**Service Letter #:** SL13-1547502

**Part/Assembly #:** 15-47502 In-Aircraft Hydraulic Line Installation, Aerocet Model 1500 Floats.

**Float Model/Aircraft Affected:** 1500 Amphibious Model Floats, Float Serial Numbers 0415-04-1500 and previous.

**Subject:** Product Improvements on Aerocet In-Aircraft Hydraulic Line Installation P/N 15-47502, Aerocet Model 1500 Floats.

**(Fig. 1)**

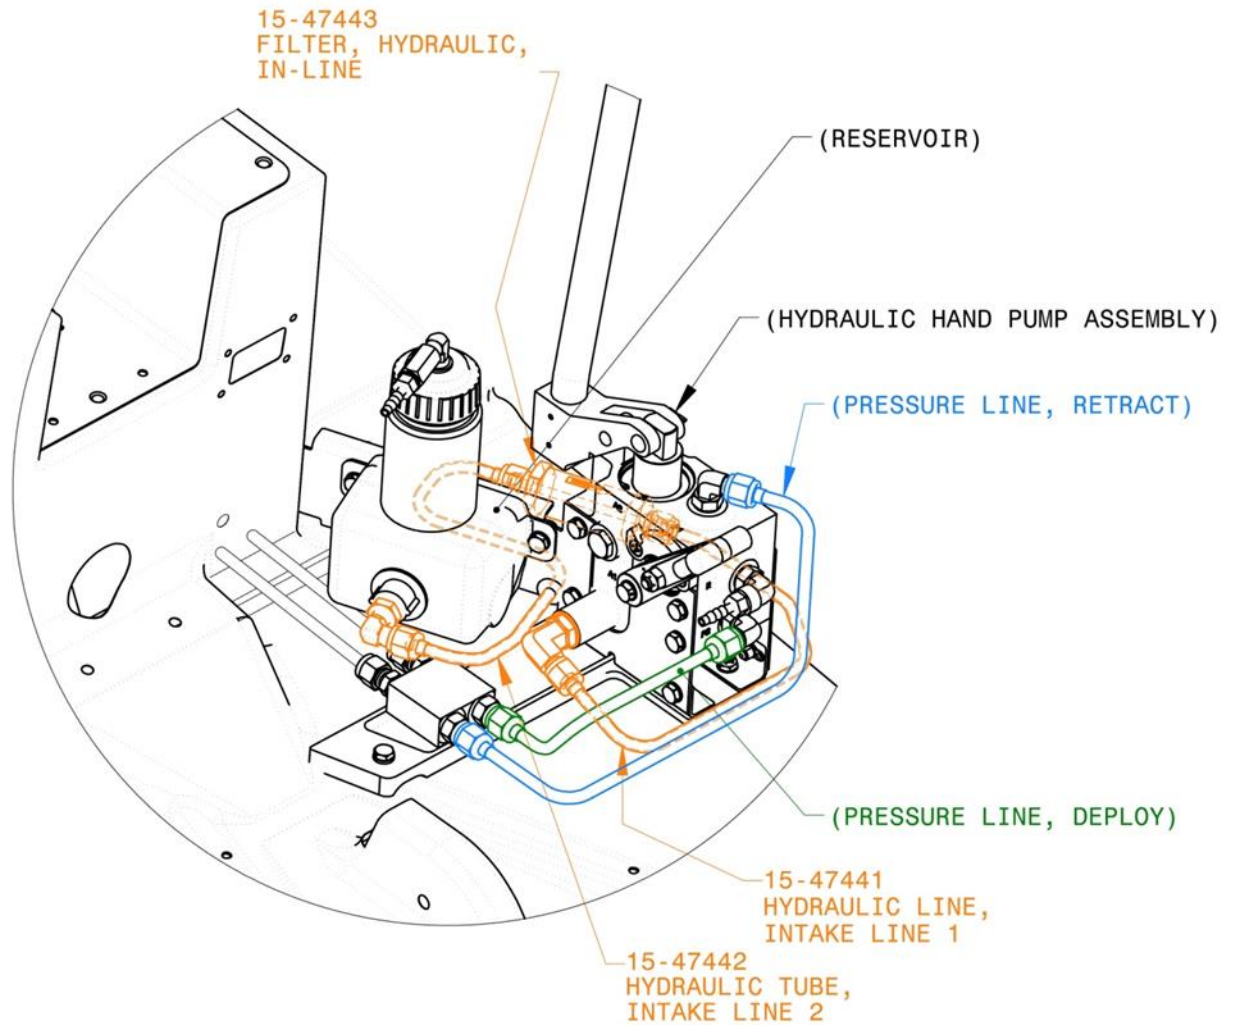
Newer design improvements incorporate an in-line filter to the hydraulic landing gear operation system, between the Hydraulic Reservoir Tank (15-47400) and the Hydraulic Hand Pump (15-47050) inlet port. Add two new hydraulic lines, two 90° fittings and a support bracket to existing aircraft stud. (See Figures) (Note direction of fluid flow and orientation of filter.)

(Fig. 2)

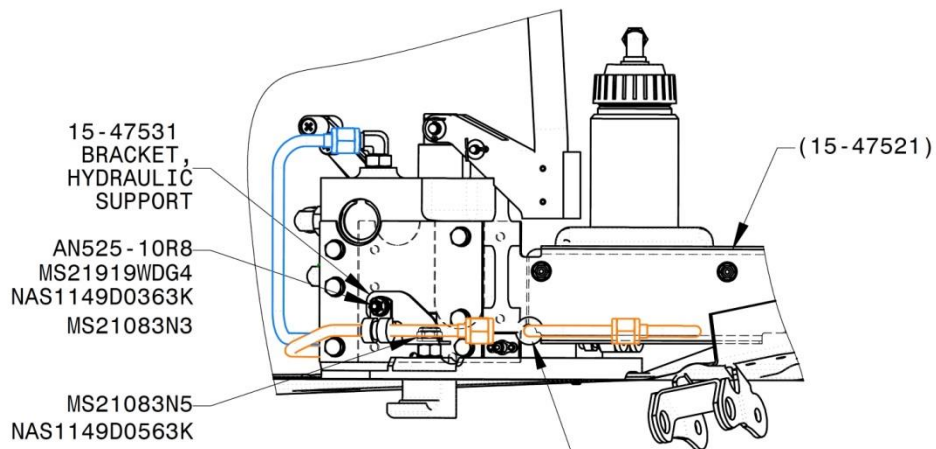
- 2) Drain hydraulic fluid from reservoir into a suitable container as closely to the reservoir as possible to minimize losses. (discard old fluid in accordance with local and federal regulations)
- 3) Remove the existing Hydraulic Line and Fitting from Hydraulic Reservoir and discard.
- 4) Remove Hydraulic Line and Fitting from Hand Pump and discard.
- 5) Install MS208224D Elbow, Flared Tube and Pipe Thread, 90 Deg. In Hydraulic Reservoir Tank Assembly. Direction of Fitting to be similar as shown in (Fig. 2).
- 6) Install 66-47147 SAE Straight Thread Elbow into Hydraulic Hand Pump inlet port. Direction of Fitting to be similar as shown in (Fig. 2).

**View from outboard, left hand side  
 (Fig. 3)**

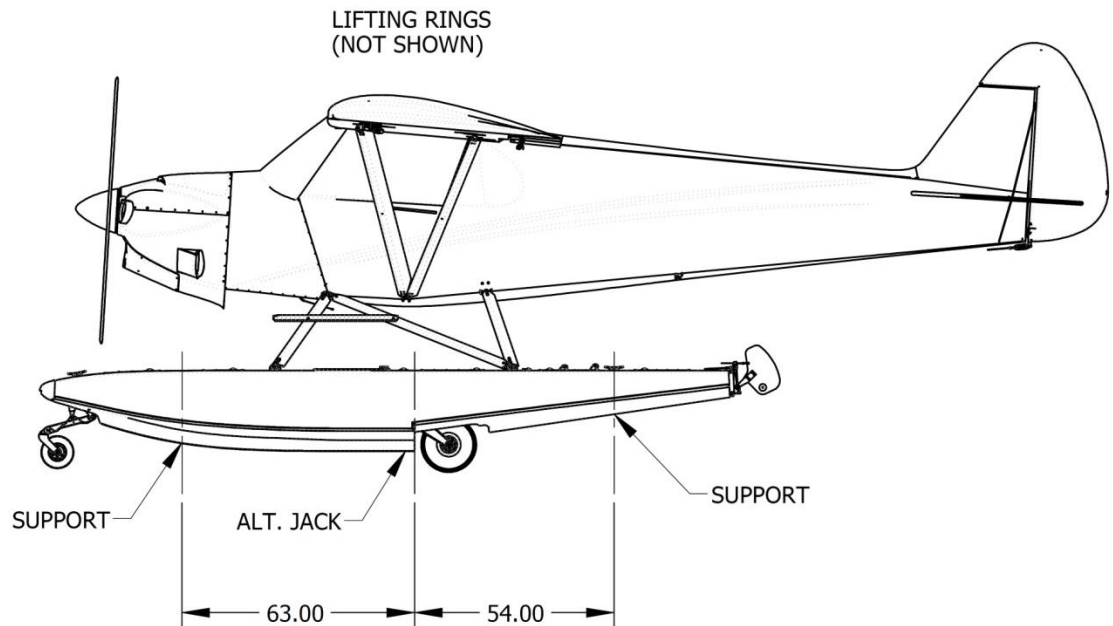
FOR RETROFIT PURPOSES:  
 REMOVE MATERIAL IN CORNER  
 OF 15-47521 TO A RADIUS  
 OF R.219 (Ø.438) TO ALLOW  
 FITTING OF MS35489 GROMMET  
 GROMMET MUST BE SLIT TO  
 ALLOW INSTALLATION OVER  
 HYDRAULIC TUBE

- 7) For retrofit purposes , remove material in corner of 15-47521 to a radius of R.219 (Ø.438) to allow fitting of MS35489-6 Grommet. Grommet must be slit to allow installation over Hydraulic Tube.
- 8) Install 15-47531 Bracket, Hydraulic Support to existing aircraft stud as shown in (Fig. 3)
- 9) Freely Route Hydraulic Lines and Filter as shown in figures 1, 2, and 3
- 10) Affix 15-47442 Hydraulic Tube, Intake Line 2 to 15-47531 Bracket, Hydraulic Support with MS21919WDG4 Wedge Clamp and associated hardware.
- 11) Torque Hydraulic Lines to 40-65 Inch-Pounds.
- 12) Refill Hydraulic Fluid Reservoir as required. Cycle landing gear up and down without pressuring multiple times or until all air is purged from the system.
